Project Name: * Widening of I-440 from Wade Avenue to Walnut Street

Subject: **Request for Modification to the Regional General Permit Number 198200031, Section 401 Water Quality Certification, and Neuse Buffer Authorization for U-2719 – Improve Existing I-440 Beltline, from south of SR 1313 (Walnut Street) to north of SR 1728 (Wade Avenue). Debit WBS 35869.1.2**

Explanation of Permit Impact Site Modifications Being Requested

WETLAND & STREAM IMPACTS
PERMIT MODIFICATION
04/02/2021

PERMIT DRAWING
SHEET 16 OF 48

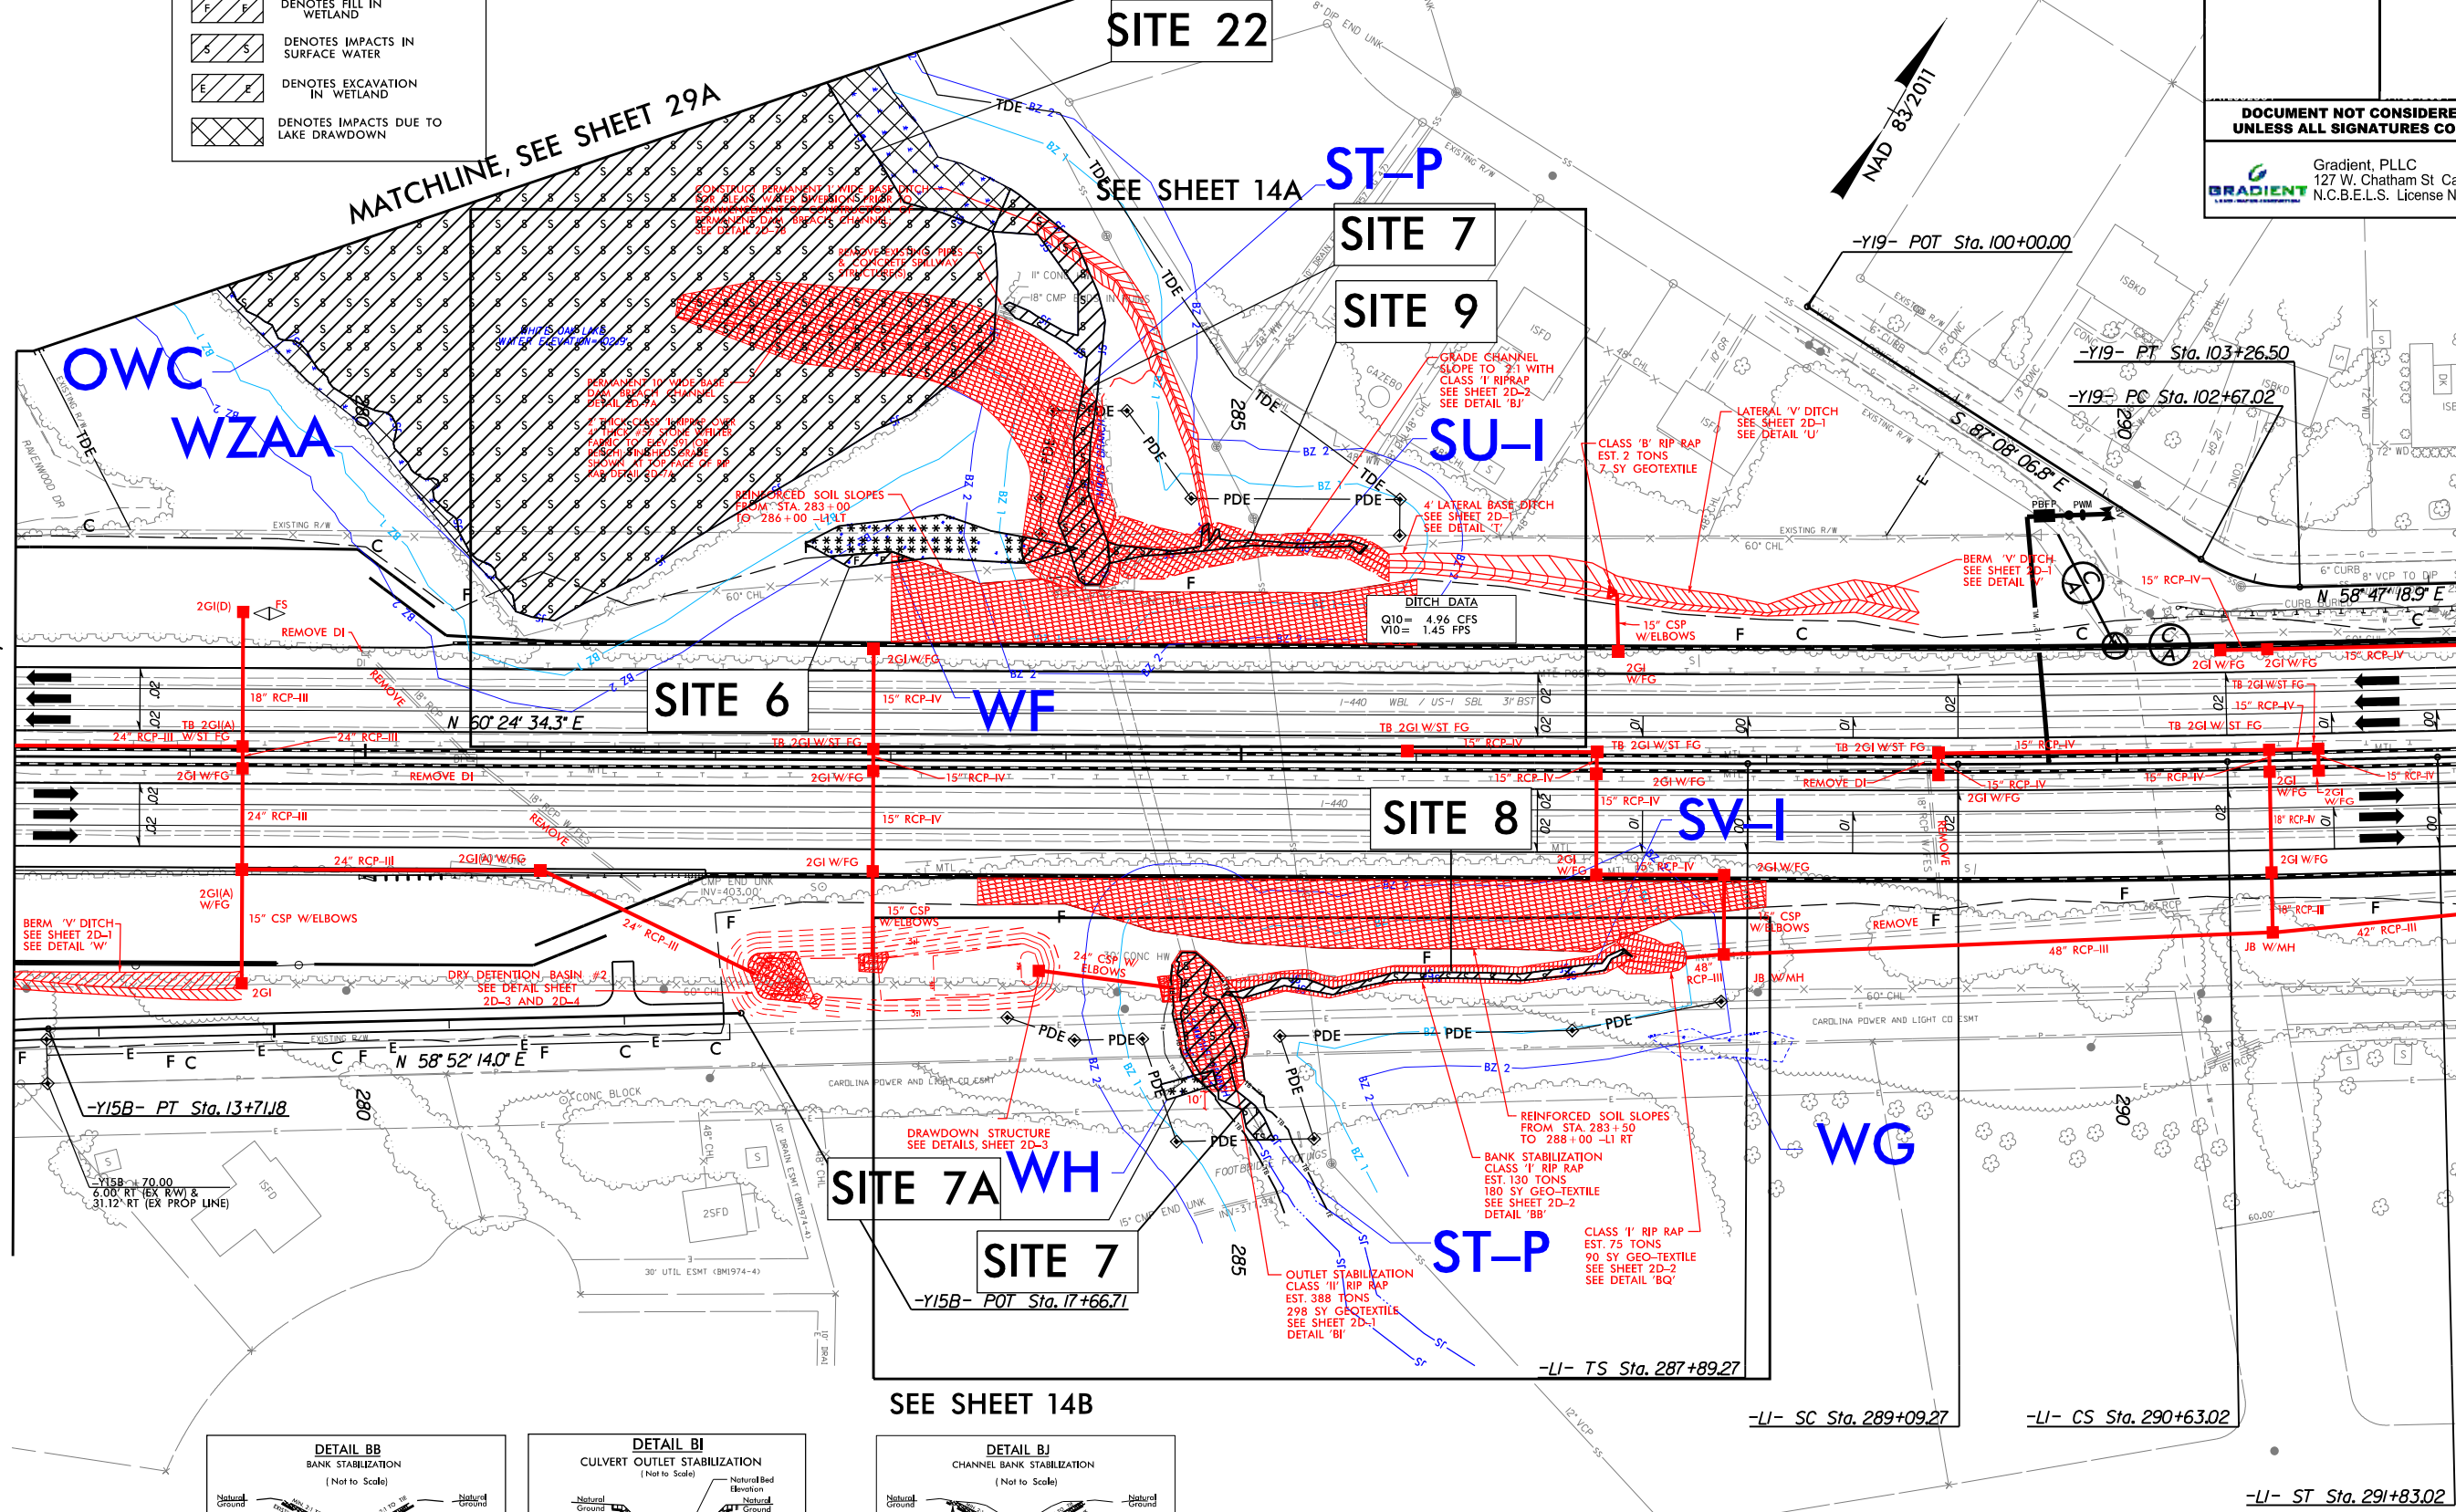
Site 6 (Sheet 14) – Site 6 has an increase of 0.04 ac of wetland impacts due to mechanized clearing. This impact is a result of the additional rock stabilization needed along the roadway fill slope and access for breaching the dam. The impact at Site 6 is now 0.01 ac of permanent fill and 0.05 ac of mechanized clearing.

Site 7 (Sheet 14) – Site 7 has an increase in permanent stream impacts and buffer impacts due in part to the new delineation as well as the extended impacts related to the dam breach. The increase in permanent stream impacts is due to relocation and stabilization of the stream once the dam is breached. The new stream impact for Site 7 is 298 lf of permanent stream impact from the dam breach to the inlet, 97 lf of outlet protection, and 22 lf of temporary stream impact. This is an increase in permanent stream impact by 360 lf and a reduction of 28 lf of temporary impact for Site 7.

Buffer Site 7 (Sheet 14) – Site 7 buffers have changed as they will now be impacted by the White Oak Lake dam breach and access requirements. The total impact in Zone 1 is 14,399 sq ft and Zone 2 is 6,548 sq ft for Site 7. This is an increase in Zone 1 impact by 12,939 sq ft and 5,677 sq feet in Zone 2. Site 7 buffer impacts on the outlet side were reviewed and it was determined that those have been previously cleared and are no longer illustrated as an impact.

Site 7A (Sheet 14/14B) – Site 7A has been added due to the need for extended outlet stabilization in Simmons Branch and access. The wetland will have a small amount of fill (<0.01 ac) due to the rock stabilization and the remaining portion (<0.01 ac) is shown as mechanized clearing. The wetland is within the maintained utility easement and has already been cleared through ongoing utility maintenance.

Site 9 (Sheet 14/14A) – Site 9 was slightly different based on the old JD files in the original permit application. This channel has been updated with the new JD files as described above which extends the channel approximately 85 lf. This reach was also previously impacted due to bank stabilization; however, with the changes in design at this location it was determined that the entire channel would require rock armoring to stabilize the area. This is now shown as a permanent fill/stabilization impact on the summary impact table. There is an 85 lf increase in impact due to the new JD file. The new impact is 147 lf which is shown as permanent fill/stabilization impact.

Site 10 and Site 11 (Sheet 14/14A) – Previous wetland Sites 10 (WJ) and 11 (WI) have been removed due to the most recent JD files discussed above. The area that was previously illustrated as wetland is part of stream SU-I in the revised delineation. This results in a reduction in wetland impact by <0.01 ac of excavation and <0.01 ac of mechanized clearing for Site 10 and <0.01 ac of excavation and <0.01 ac of mechanized clearing for Site 11.

Site 22 (Sheet 14/14A/29A) – Site 22 was added to illustrate the open water impacts associated with breaching the dam of White Oak Lake. The open water impact associated with the breach is 5.10 ac. This site also includes impacts to the fringe wetlands around the lake due to the drawdown of the lake. This area has been hatched on the attached plan sheets and the 2.65 ac of wetland fringe has been noted at the bottom of the summary impact table since it does not match any of the wetland impact types illustrated on the summary table.

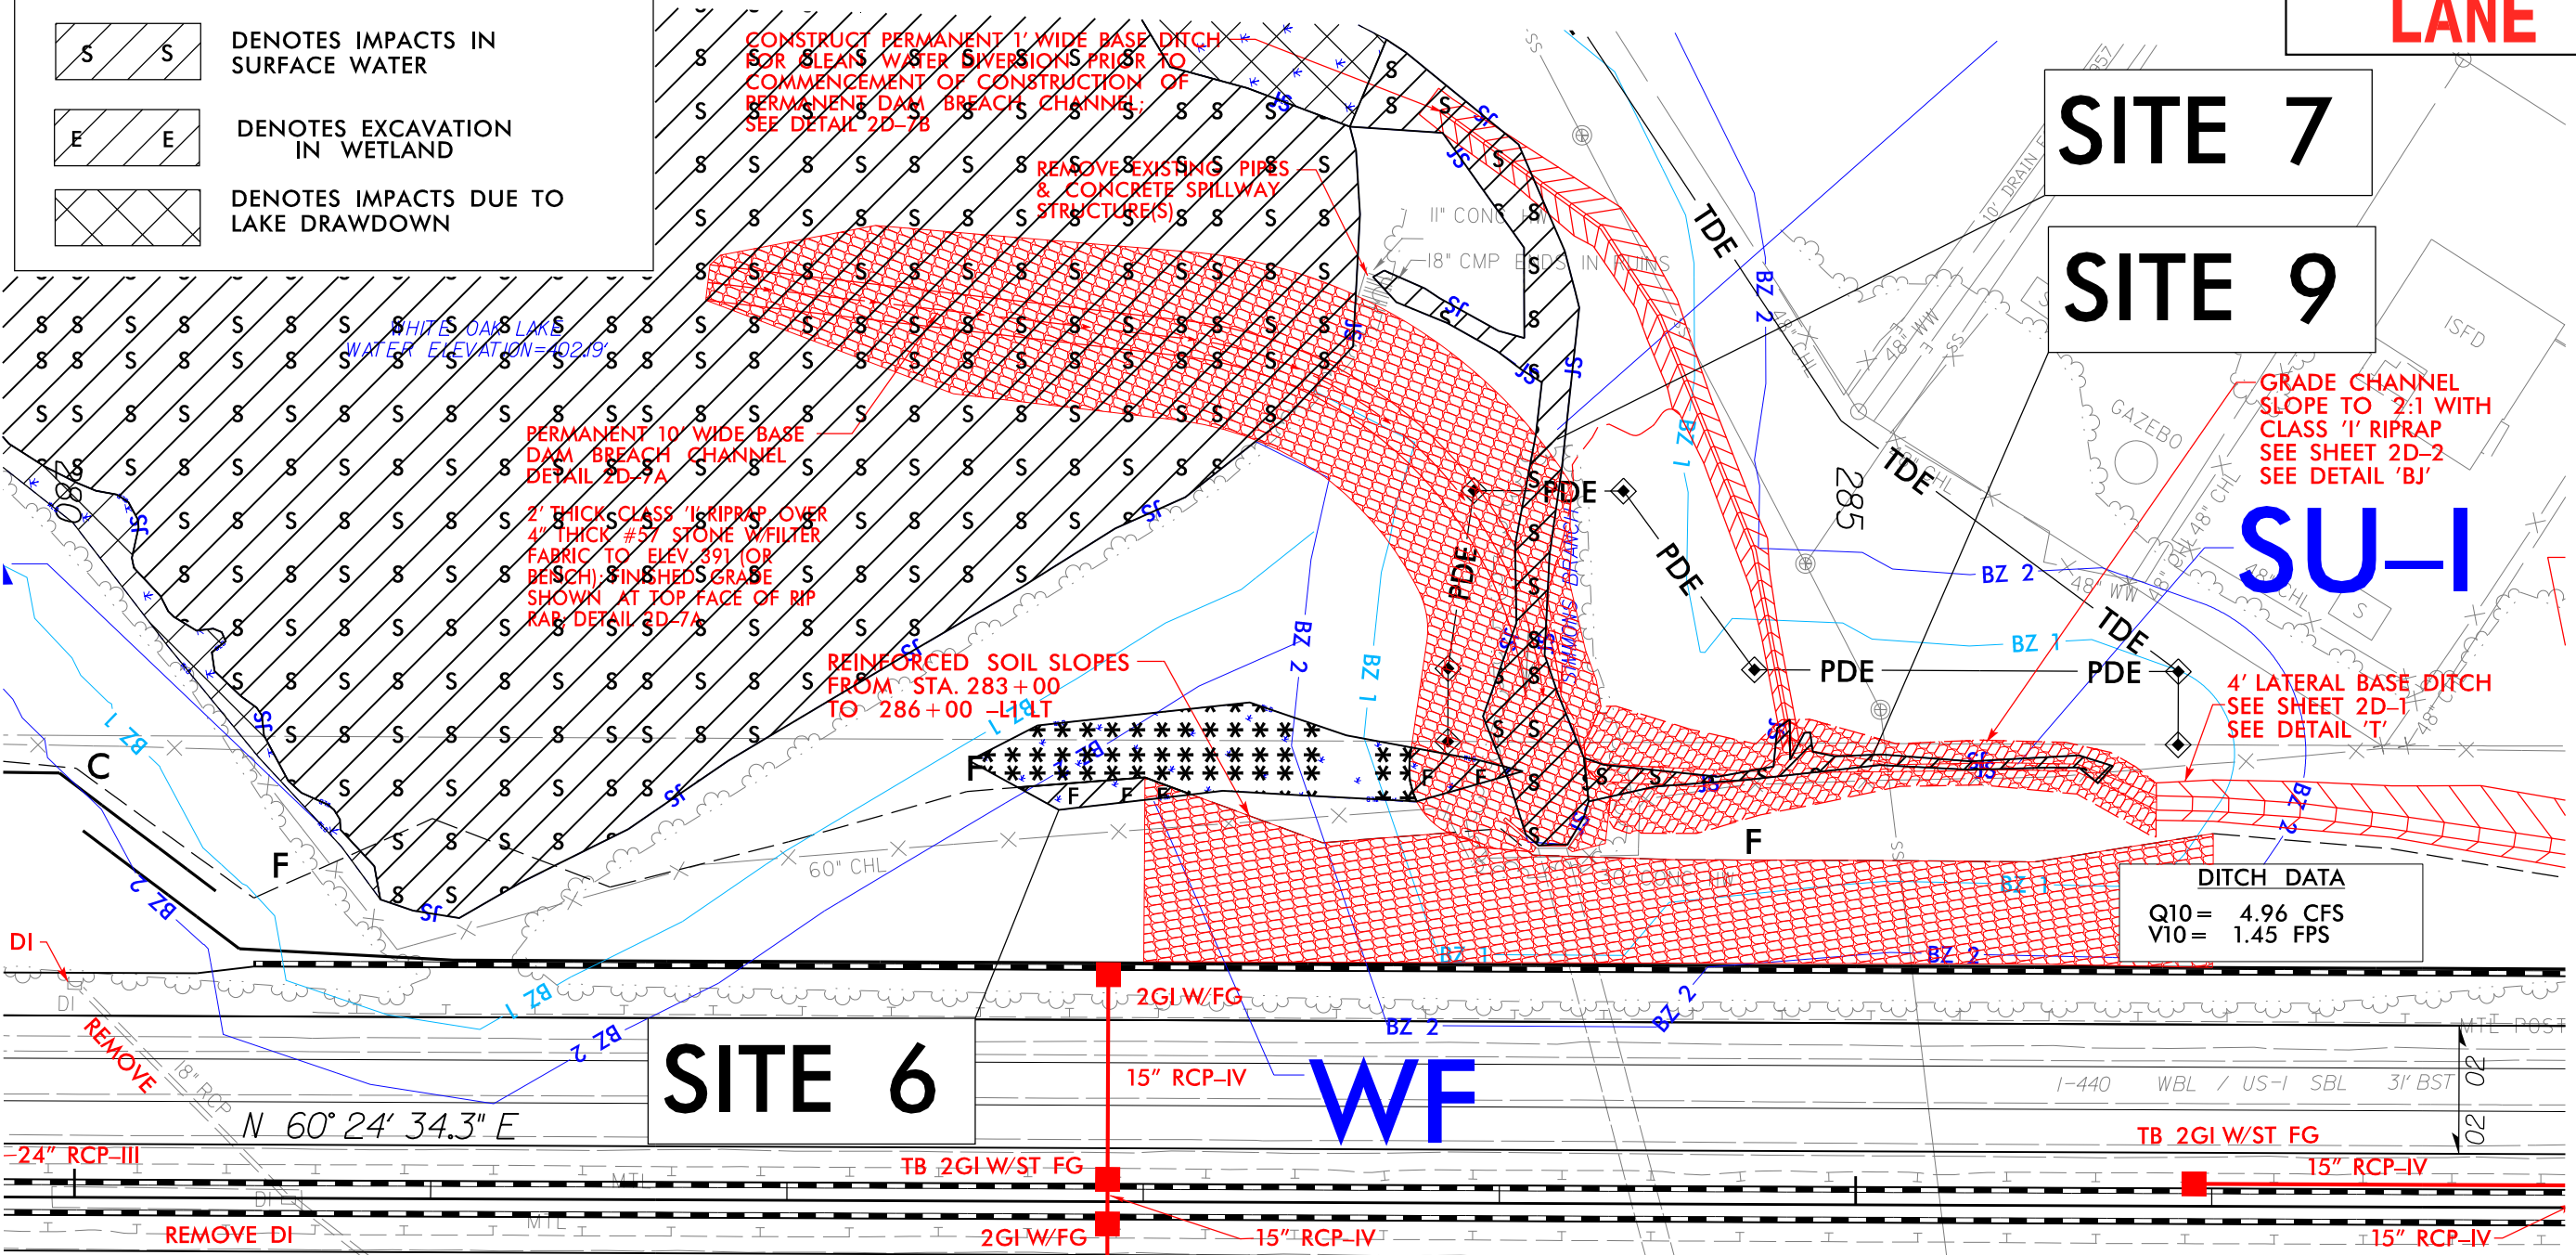
Buffer Site 9 (Sheet 14/14A) – Site 9 buffers have also changed as a result of the new JD file. Site 9 buffer impacts have increased in Zone 1 by 2,708 sq ft to 6,639 sq ft. Zone 2 buffers have increased by 1,392 to 2,738 sq ft. No additional buffer mitigation is proposed for the additional buffers associated with the new JD file, as redesign and impacts are linked to the dam breach impacts which were previously considered non-mitigable by NCDWR.

Buffer Site 10 (Sheet 14/14A) – Previously there were no impacts illustrated with the buffers around White Oak Lake due to the City of Raleigh project. The buffer impacts illustrated at Site 10 are associated with construction and access for the dam breach at White Oak Lake. This results in 10,337 sq feet of Zone 1 impacts and 4,597 sq ft of Zone 2 impacts.
